AMENDMENT OF SOLICITATION

Solicitation No. and Title CSP 24-040 Citywide Pedestrian Improvement		2. Amendment No. 2	3. Effective Date of this Action 10/18/2024
4. Name and Address of Offeror or Contractor	5. For Information Call: (No collect calls or Fax offers accepted) Purchasing: Barbara Coleman Phone No.: 830-221-4389 Email:		6. Amount of Contract/Order is: Increased by: Decreased by: New Total: <input checked="" type="checkbox"/> Unchanged

CITY OF NEW BRAUNFELS CITYWIDE PEDESTRIAN IMPROVEMENTS

PACKAGE 2 - A2, SW1 & SW3
(FINAL BID SET)
OCTOBER 2024

TRANSPORTATION AND CAPITAL IMPROVEMENTS

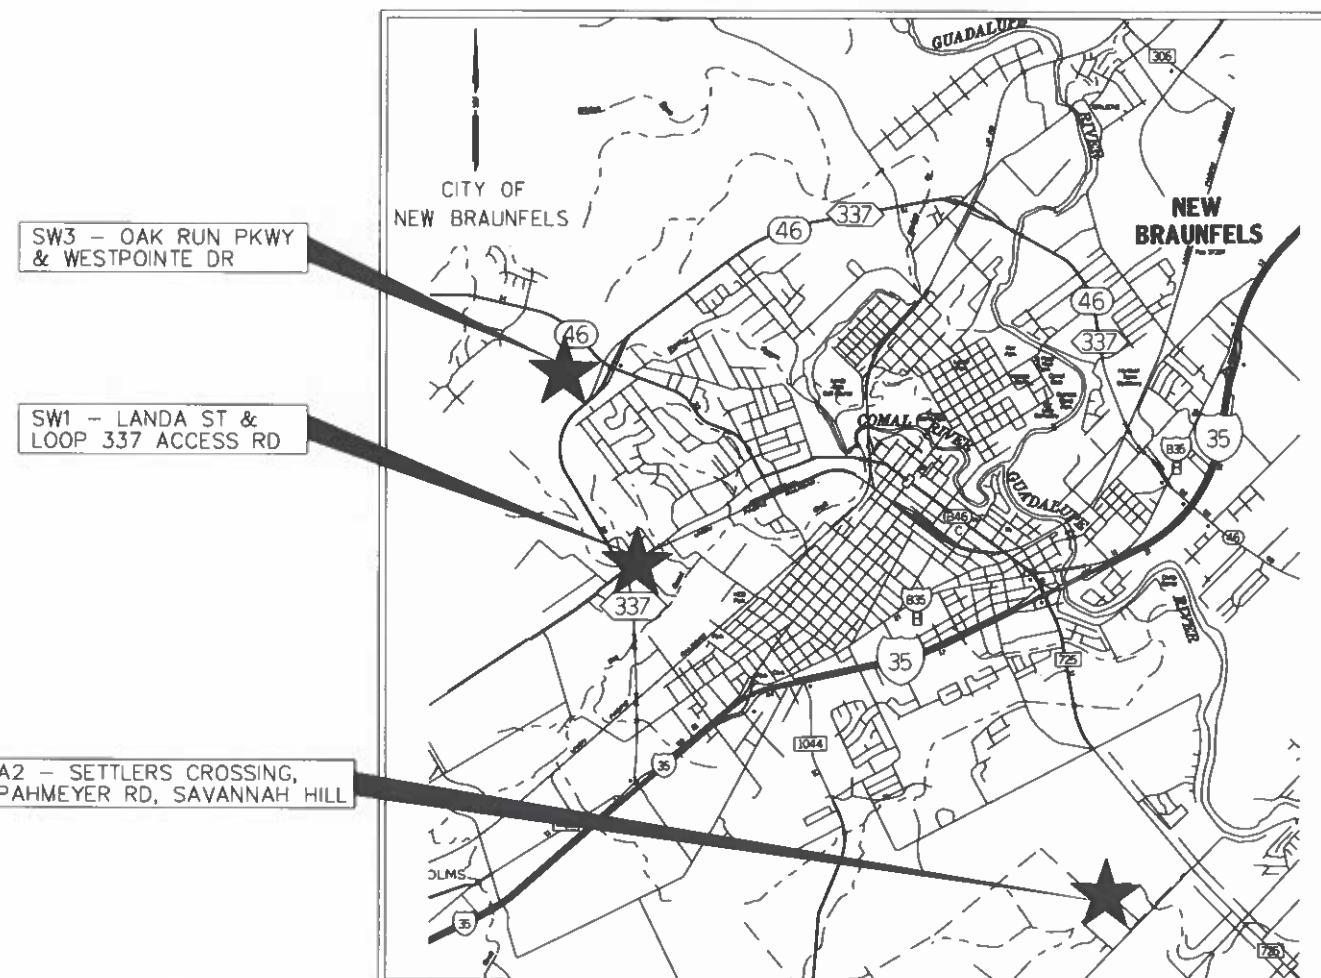
1. Remove Sheet 1 and replace with attached Sheet 1 dated 10/17/2024 updated with TDLR number.
2. Remove Sheet 2A and replace with attached Sheet 2a dated 10/17/2024 reflecting updated Development Note 11.
3. Remove Sheet 8 and replace with attached Sheet 8 dated 10/17/2024 to reflect updated Curb and Gutter detail.
4. Remove Sheet 8A and replace with attached Sheet 8A dated 10/17/2024 to reflect updated Curb and Gutter detail.
5. Remove Sheet 9 and replace with attached Sheet 9 dated 10/17/2024 to reflect updated island details and signs.
6. Remove Sheet 10 and replace with attached Sheet 10 dated 10/17/2024 to reflect median nose modification details.
7. Remove Sheet 13 and replace with attached Sheet 13 dated 10/17/2024 to reflect updated island details and signs.

REGISTERED ACCESSIBILITY SPECIALIST INSPECTION REQUIRED
TDLR NO. TABS2025000685
